QUALITY ASSURANCE -- NON-CONFORMANCE REPORT

Location: Changxing Island, Shanghai, P.R. China **Report No:** NCR-000922
Prime Contractor: American Bridge/Fluor Enterprises, a JV **Date:** 25-Nov-2010
Submitting Contractor: Zhenhua Port Machinery Company, Ltd (ZPMC), Changxing Island **NCR #:** ZPMC-0884

Dear: Mr. Charles Kanapicki
Attention: Mr. Thomas Nilsson Project/Fabrication Manager
Subject: NCR No. ZPMC-0884

Job Name: SAS Superstructure
Document No: 05.03.06-000879

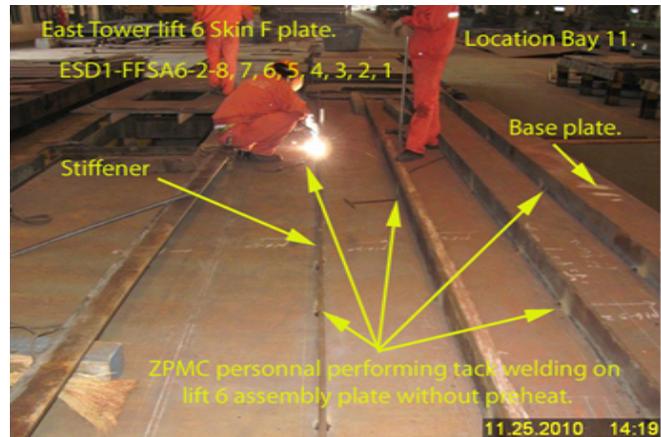
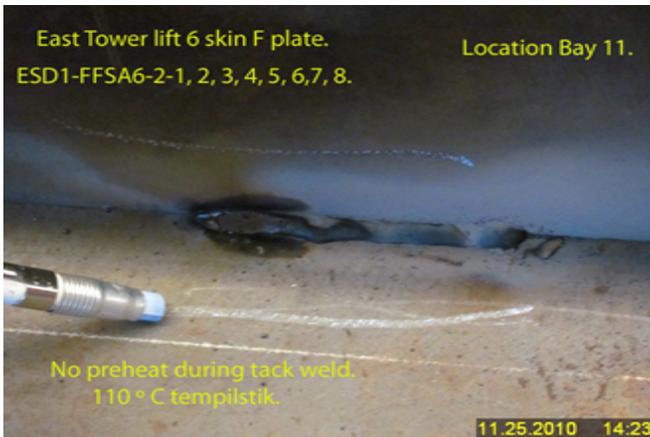
During Caltrans QA in process observations of the fabrication of ESD1-FFSA6-2, the QA discovered the following issue:

ZPMC welding personnel did not appear to be following the WELD PROCEDURE REQUIREMENTS FOR NEW WELDS (Rager/ McQuaid), i.e. Preheat shall be applied in such a manner to provide a minimum temperature in the area of the weld of 165 degree Celsius.

- The welds are identified as: ESD1-FFSA6-2-1, 2, 3, 4, 5, 6, 7, 8.
- The welding process used was SMAW
- The area was not preheated.
- The welds are Fillet Welds joining stiffener plates to skin plate
- The member is not SPCM
- ESD1-FFSA6-2 is located in Bay 11.

Reference Resolution: As this NCR was written without a contractual basis it should be withdrawn.

We understand your response. However, successful NDT will close this NCR.

There are no records for issued green tags on these components. Please submit the NDT reports in order to close out this NCR.

See attached NDT results to show the weld is acceptable. Based on this ZPMC requests closure of this NCR.

This proposed resolution is acceptable. The documentation received is sufficient and the Department concurs that Non-Conformance ZPMC-0884 is closed.

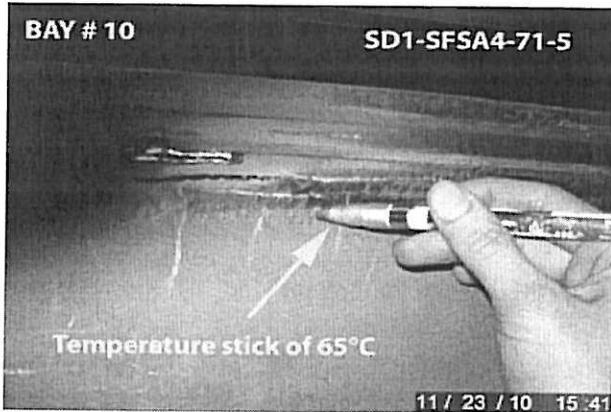
During Caltrans QA in process observations of the fabrication of SD1-SFSA4-71, the QA discovered the following issue:

ZPMC welding personnel did not appear to be following the WELD PROCEDURE REQUIREMENTS FOR NEW WELDS (Rager/ McQuaid), i.e. Preheat shall be applied in such a manner to provide a minimum temperature in the area of the weld of 165 degree Celsius.

- The weld is identified as: SD1-SFSA4-71-5
- The welding process used was SMAW
- The area was being preheated using torch
- The weld is as Fillet joining top plate to side plate
- The component is not SPCM
- The component (SD1-SFSA4-71_ is located in Bay 10.

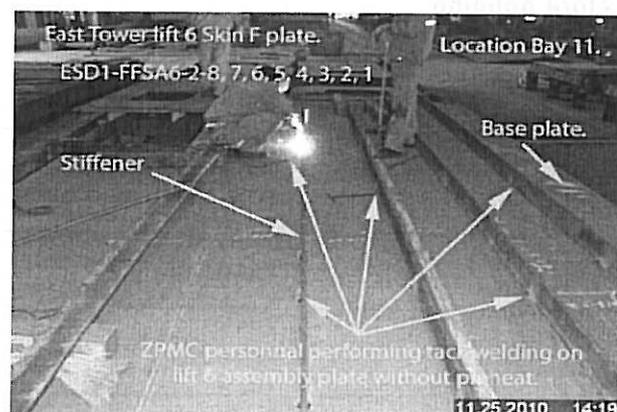
During Caltrans QA in process observations of the fabrication of ESD1-FFSA6-2, the QA discovered the following issue:

ZPMC welding personnel did not appear to be following the WELD PROCEDURE REQUIREMENTS FOR NEW WELDS (Rager/ McQuaid), i.e. Preheat shall be applied in such a manner to provide a minimum temperature in the area of the weld of 165 degree Celsius.

-The welds are identified as: ESD1-FFSA6-2-1, 2, 3, 4, 5, 6, 7, 8.

Contractor will provide the NDT report to prove the welds are acceptable.

NDT report is provided by the Contractor. The report shows the welds are acceptable.
